**World Forum for Harmonization of Vehicle Regulations****Working Party on Lighting and Light-Signalling****Sixty-sixth session**

Geneva, 4–6 October 2011

**Regulation No. 48 (Installation of lighting and  
light-signalling devices) - Proposal for Supplement 1  
to the 05 series of amendments****Proposal for Supplement 1 to the 05 series of amendments****Submitted by the expert from Poland\***

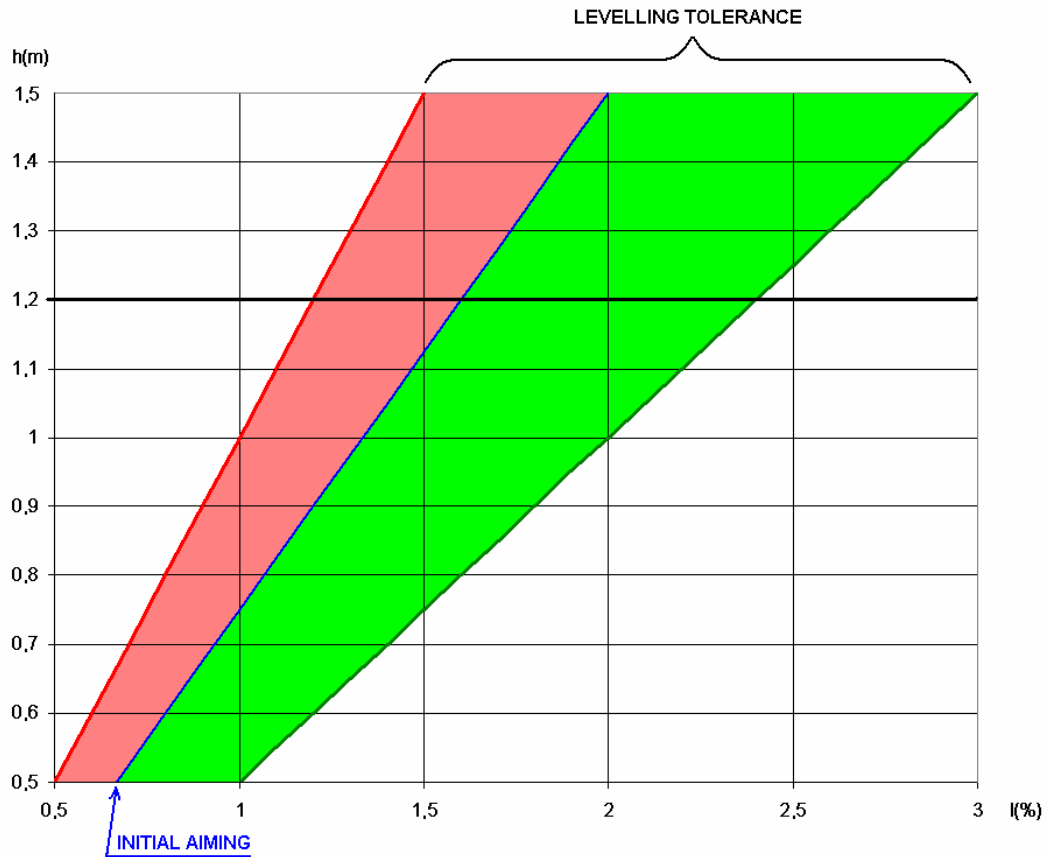
"6.2.6.1.2. Depending on the mounting height in metres (h) of the **dipped-beam headlamp reference axis, the vertical inclination of the cut-off of the dipped beam, (in the direction of the reference axis) measured on the unladen vehicles, taking in account 0.1 per cent accuracy, shall have the value of initial aiming for which the horizontal part of cut-off crosses the surface of flat horizontal road at the distance of 75 m from the headlamp.**

**The aiming limits under all the static conditions of Annex 5 should be such that the distance of crossing of the vertical part of cut-off with road surface shall remain between [50 m] and [100 m].**

~~h < 0.8~~

~~limits: ————— between 0.5 per cent and 2.5 per cent~~

~~initial aiming: ————— between 1.0 per cent and 1.5 per cent~~

~~0.8 < h < 1.0~~

~~limits: ————— between 0.5 per cent and 2.5 per cent~~

~~initial aiming: ————— between 1.0 per cent and 1.5 per cent~~

~~Or, at the discretion of the manufacturer,~~

~~limits: ————— between 1.0 per cent and 3.0 per cent~~

~~initial aiming: ————— between 1.5 per cent and 2.0 per cent~~

~~The application for the vehicle type approval shall, in this case, contain information as to which of the two alternatives is to be used.~~

~~h > 1.0~~

~~limits: ————— between 1.0 per cent and 3.0 per cent~~

~~initial aiming: between 1.5 per cent and 2.0 per cent~~

The above limits and the initial aiming values are summarized in the diagram below.
